19  
20 **12. Media Access Method Dependent Convergence Functions**

21  
22  
23 **12. ~~Support of the Internal Sublayer Service by specific MAC procedures~~**  
24

24  
25 << Commenter's note: Here's the latest version of the 802.11 text. I've done my best to follow the instructions  
26 from the 802.1AC-REV D0.2 comment resolution, but some changes proposed, here, because of refinements  
27 in the architecture, have superseded some of the comment resolutions. >>  
28  
29

**Figure 12-1—IEEE 802.11 portal convergence function method**

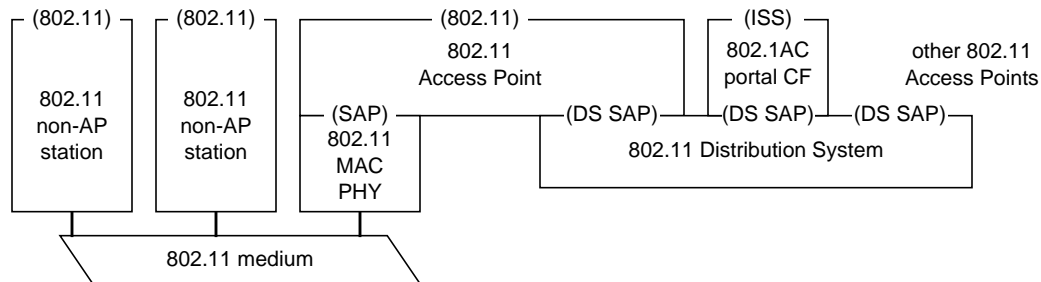
As shown in Figure 12-1, the IEEE 802.11 portal convergence function offers an instance of the ISS to upper layers, connecting to an IEEE 802.11 distribution system through an instance of the DS SAP interface defined in IEEE Std 802.11-2012 Clause R.1. IEEE 802.11 non-AP stations are associated to the distribution system via one or more IEEE 802.11 access points. For a description of the IEEE 802.11 architecture, see Clause 4 of IEEE Std 802.11-2012. The IEEE 802.11 portal convergence function, together with the upper layers to which it offers a service via the ISS, constitute an IEEE 802.11 portal.

NOTE—As shown in Figure 12-1, the IEEE 802.11 portal convergence function does not supply the Controlled and Uncontrolled Ports of the IEEE 802.11 infrastructure convergence function (12.2.2). This is because the DS SAP is a service offered by the IEEE 802.11 distribution system, not a service whose peer is below the distribution system; the

**Figure 12-3—MAC security and IEEE 802.11 media**

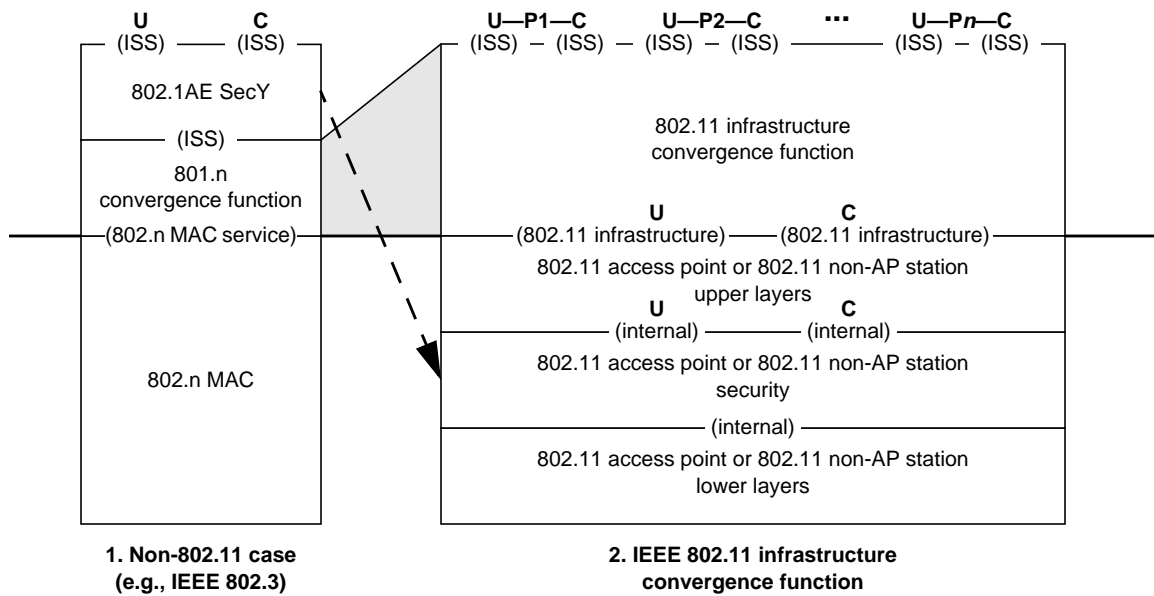
The SecY is used on some IEEE 802 media, including IEEE 802.3, but not including IEEE 802.11, in the manner illustrated in part 1 of Figure 12-3. IEEE 802.11, however, necessarily places its security layer, with Controlled and Uncontrolled ports similar to those of the IEEE 802.1AE SecY, below the IEEE 802.11 SAP. This is because IEEE 802.11 systems protect fragments of frames, not whole frames, and those segments are created or assembled in layers between the SAP and the security layer. Therefore, the IEEE 802.1AE SecY is not typically used on IEEE 802.11 media. In order to utilize the IEEE 802.11 security layer, but provide the same services to the upper layers for IEEE 802.11 media that are provided by the SecY for other media, the IEEE 802.11 infrastructure convergence function provides an Uncontrolled Port and a Controlled Port for each virtual point-to-point LAN, which is to say, for each of the other 802.11 stations to which its access point or non-AP station is associated. This is illustrated in part 2 of Figure 12-3.

A system may connect to an IEEE 802.11 station via the IEEE 802.11 infrastructure convergence function. The infrastructure convergence function provides connections to zero or more virtual point-to-point LANs, each to another IEEE 802.11 station. The infrastructure convergence function offers two instances of the ISS to the system for each LAN, an Uncontrolled Port and an Uncontrolled Port. Figure 12-3, part 2, illustrates the infrastructure method applied to an IEEE 802.11 access point (or non-AP station) with  $n$  associated IEEE 802.11 stations.
